MODIFICATION REQUEST:

Mixed Use Development at 78-90 Old Canterbury Road, Lewisham Concept Plan

MP 08_0195 MOD 1

Director-General's
Environmental Assessment Report
Section 75W of the
Environmental Planning and Assessment Act 1979

Figure 4: Proposed Concept Plan (Source: Proponent's Section 75W application)

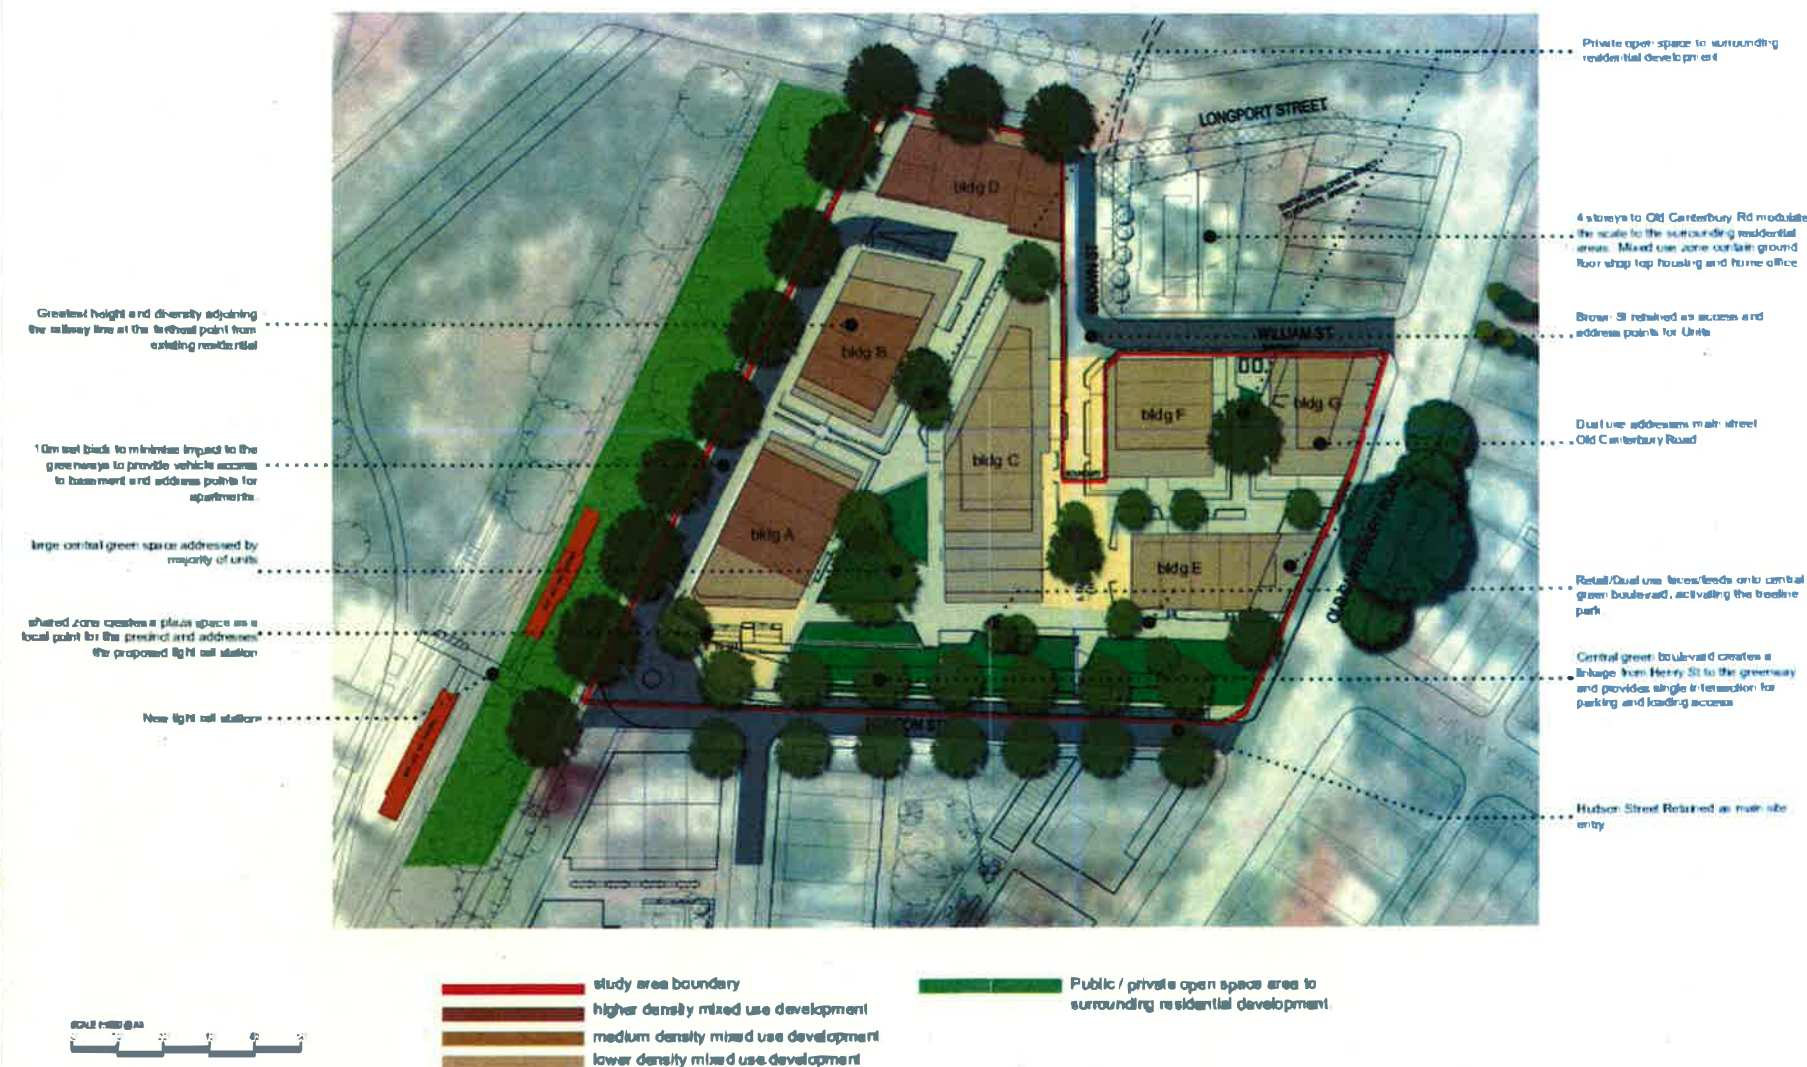
- minor adjustments to the alignment of the space between Buildings A and B;
- reduction in the size of the central open space from 3,054.4m² to 3,002.1m²;

- modulation of approved building heights;
- changes to the land use plan:
 - redefinition of the ground floor uses in Buildings A, C and G to be retail and commercial. It is proposed to make provision for these spaces to be "dual use", enabling them to be used for either residential or non-residential; and

- deletion of the requirement for non-residential land use along the north-south access road.
- vary the minimum solar access requirements from a minimum of 3 hours between 9.00am and 3.00pm in mid-winter to a range of between 2 and 3 hours;

- clarify the manner of providing the component of affordable housing within the development;
- reduce the solar access requirements to primary living spaces from a minimum of 3 hours between 9.00am and 3.00pm in mid-winter to 2 hours;

- amendment to requirement for widening of the footpaths in William Street to adjust the footpath requirements; and
- amendment to requirement for all future applications to demonstrate that all necessary approvals have been obtained from Sydney Airports Commission and Air Services Australia.
